Addendum #2
ITB # 23-20, Stainless Steel Manhole Inserts
02/25/2020

NOTICE IS HEREBY GIVEN that the following addendum serves to provide clarification and to answer the questions received on ITB #23-20, Stainless Steel Manhole Inserts.

USF 420 Manhole Ring and Cover Specification

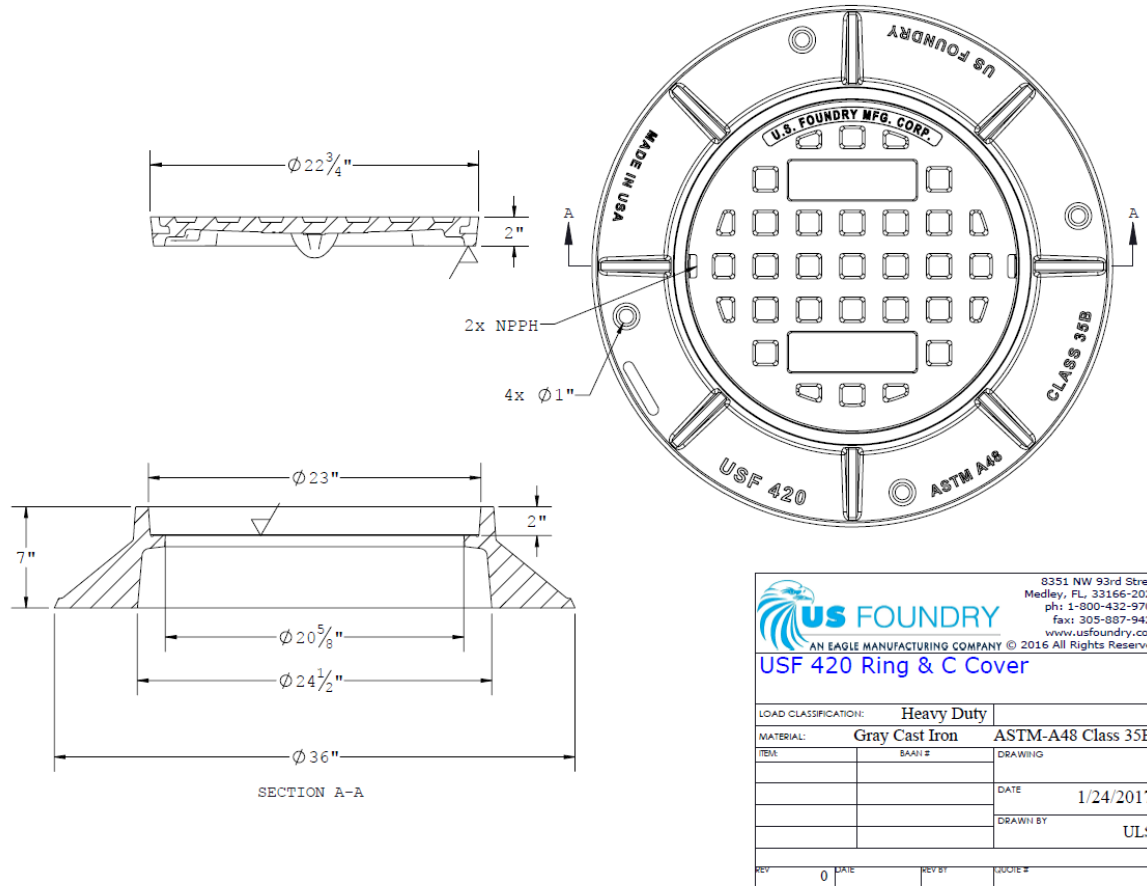
Question 1: May we have the castings or ID/OD dimensions for line items #1 and #3?

Answer to Question 1: *The specifications for Item No.1 can be located on page three (3) of this addendum and Item No.3 can be located on page five (5).*
